P&Z CASE # SP2021-017 P&Z DATE 07/13/21 CC DATE _____ APPROVED/DENIE _____

SITE PLAN
 LOT 1, BLOCK A, CREEKSIDE COMMONS ADDITION
 NWC STATE HIGHWAY 205 & F.M. 549
 A 1.50 ACRE TRACT OF LAND IN THE
 WILLIAM W. FORD SURVEY, ABST. NO 80
 CITY OF ROCKWALL, ROCKWALL COUNTY, TEXAS
 CITY PROJECT #00000
 June 10, 2021

LANDSCAPE PLANTING PLAN
 7-ELEVEN STORE
 NWC STATE HIGHWAY 205 & FM 549
 ROCKWALL, TEXAS

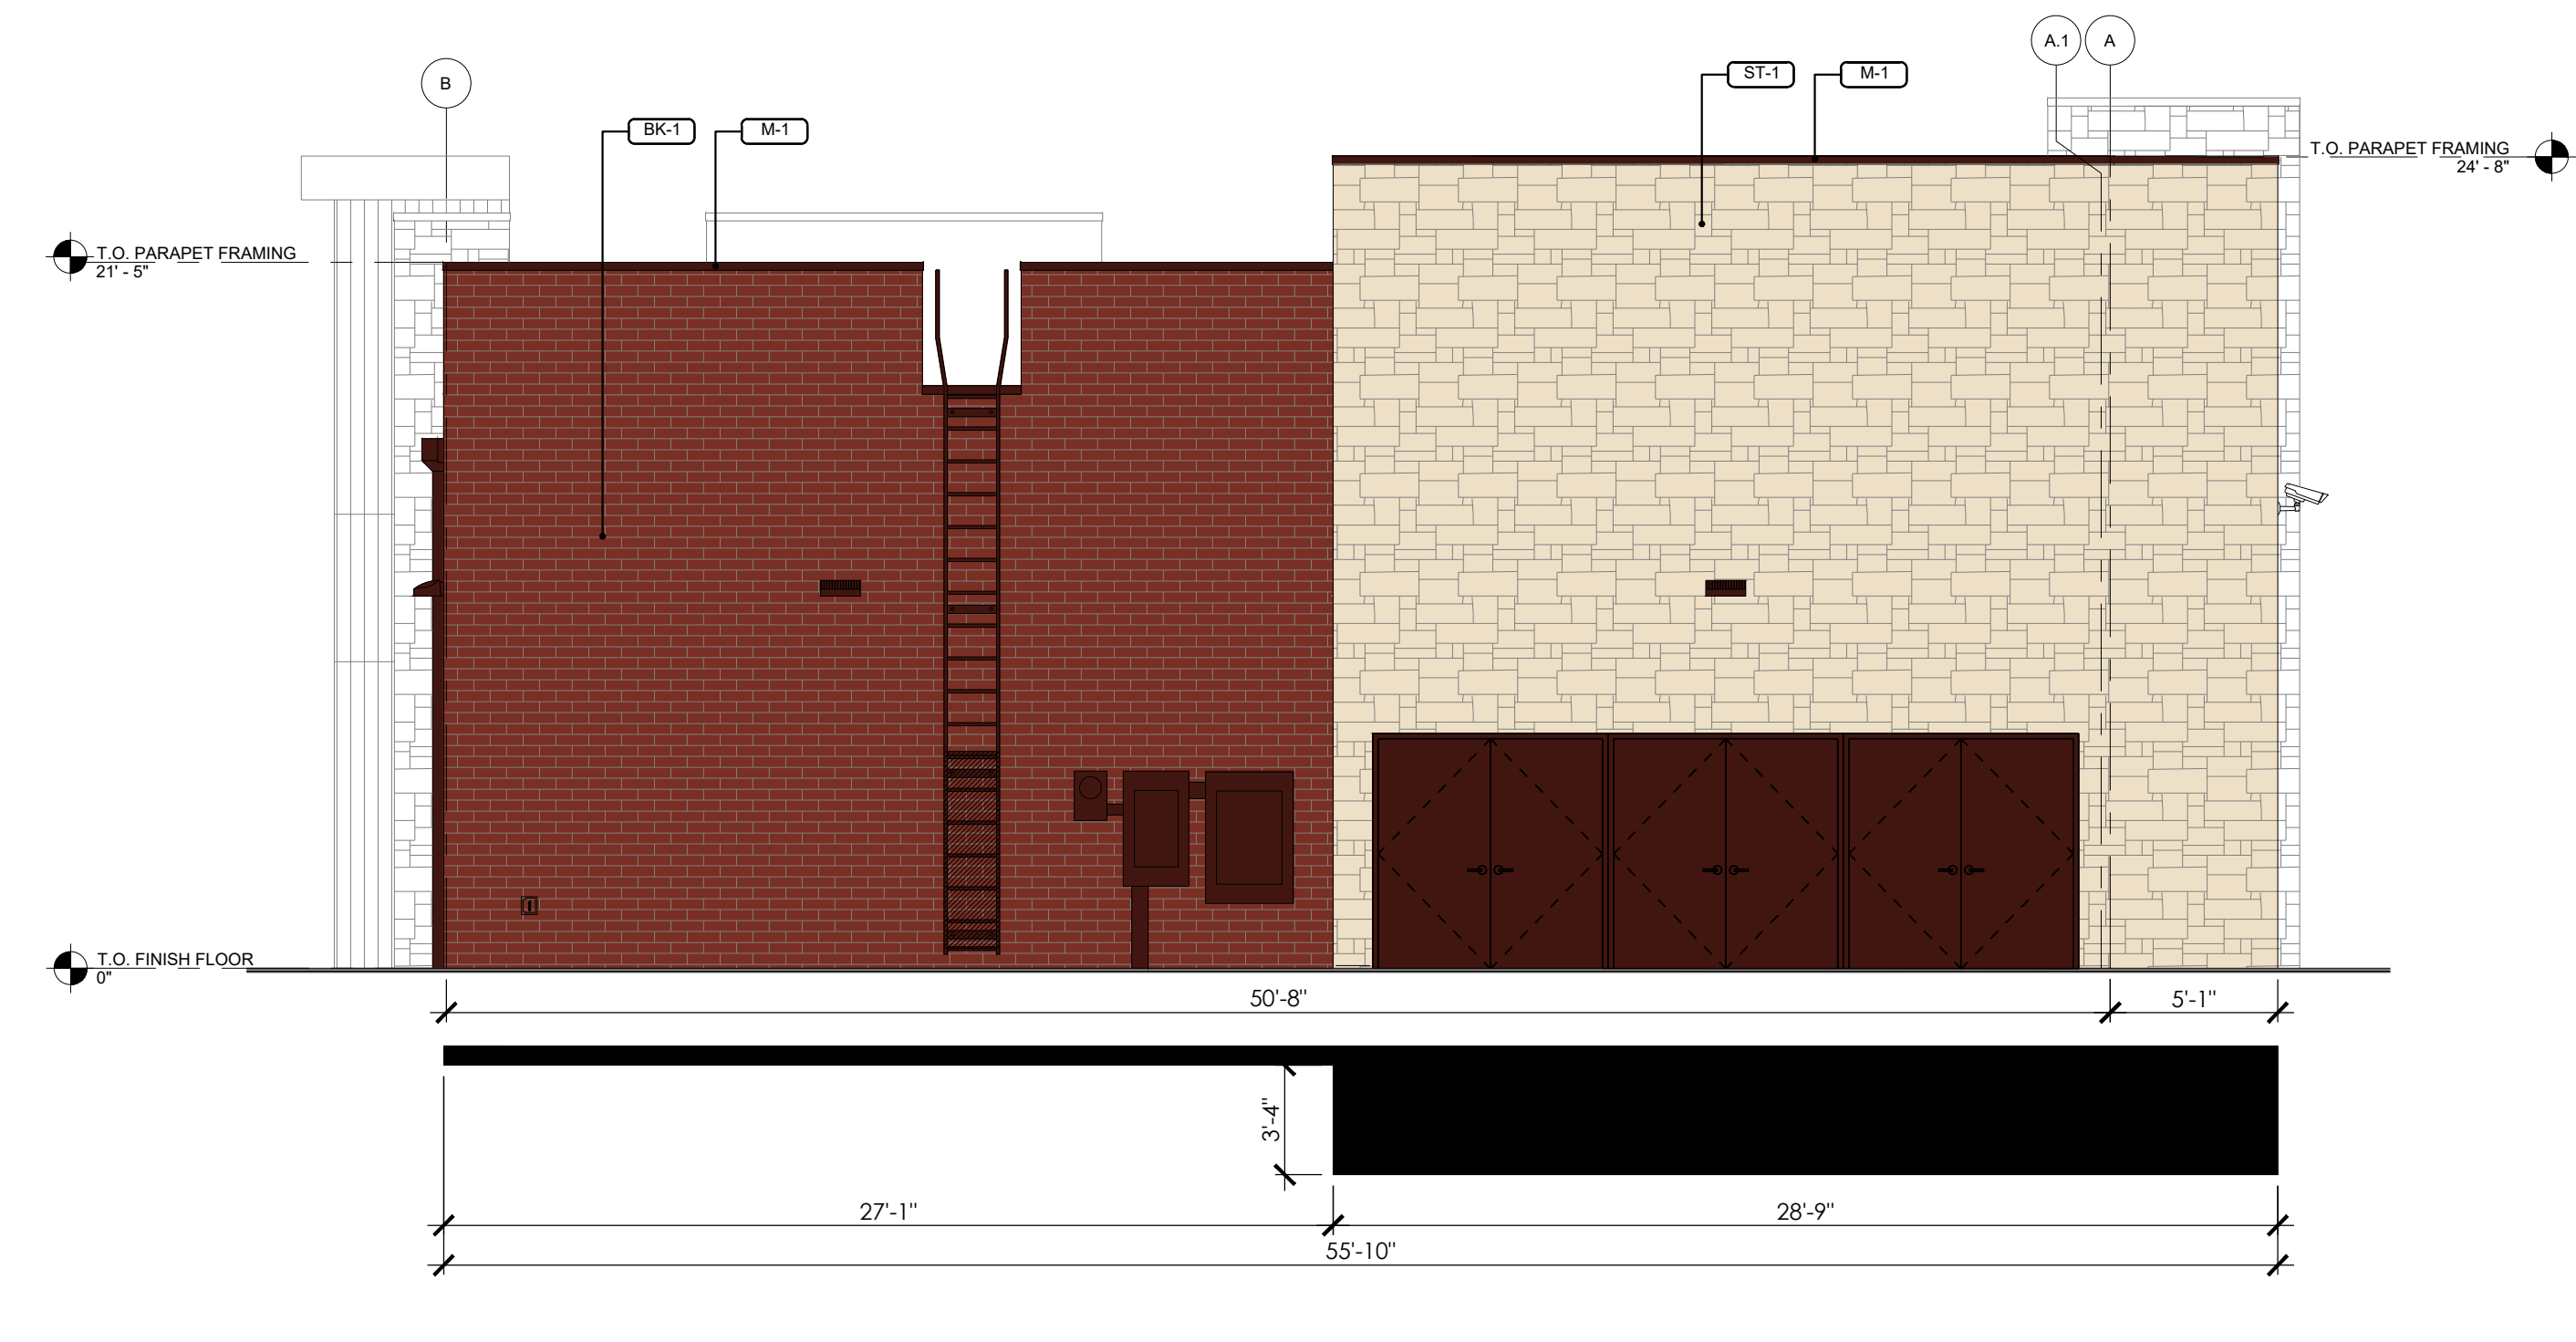
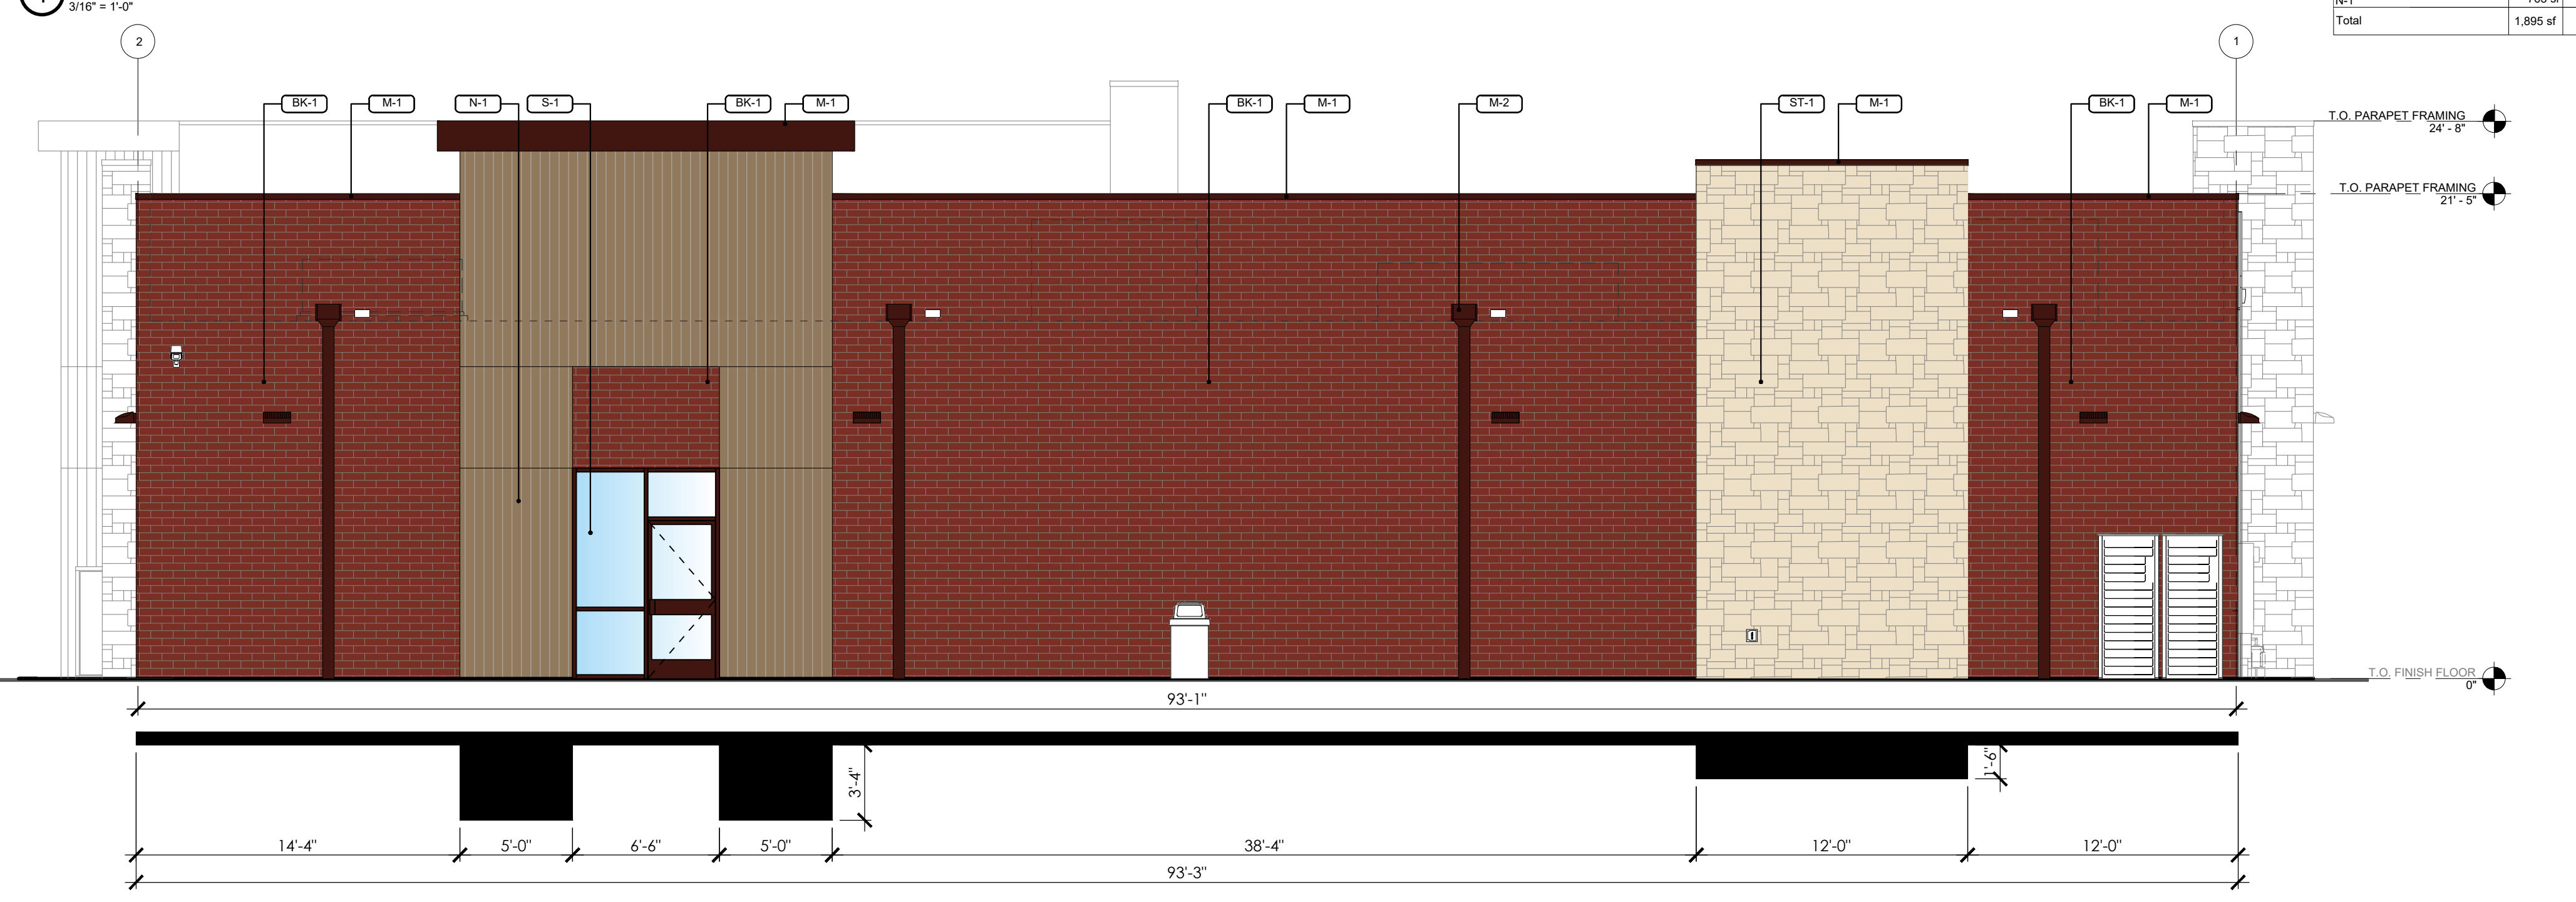
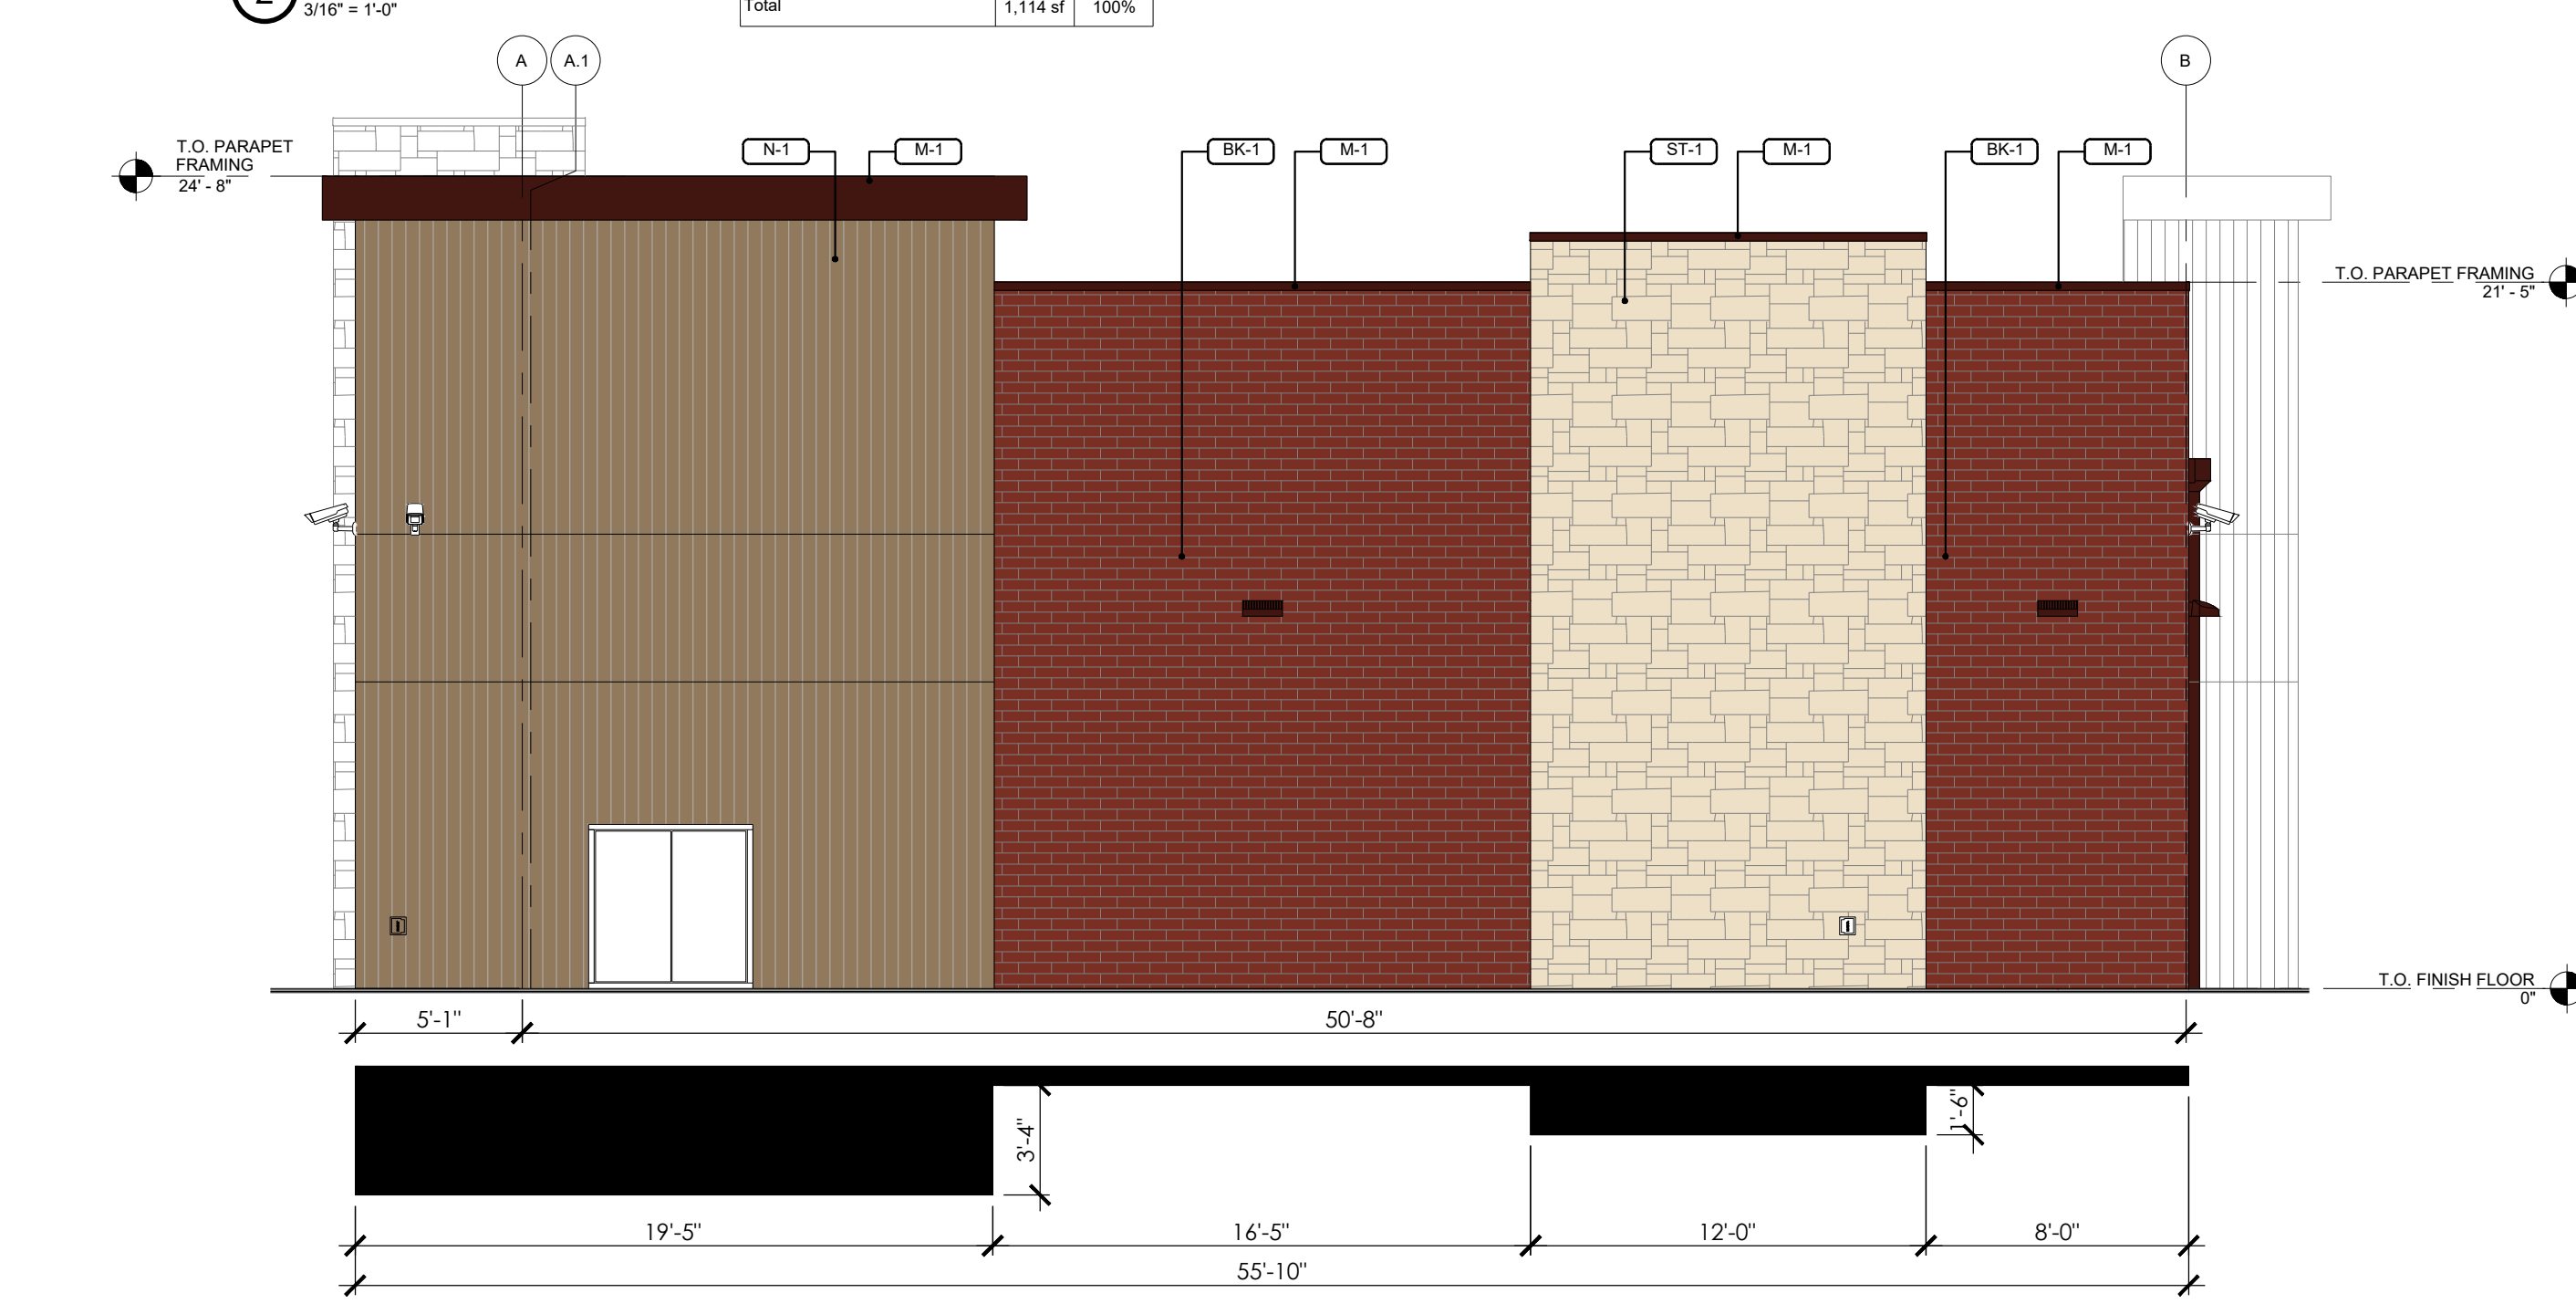
1) Building Articulation – As depicted, the building elevations do not meet the articulation standards as required in Figure 7 of Subsection 04.01.C, of Article 05, of the UDC for the following: (§04.01.C, Art. 05,UDC)
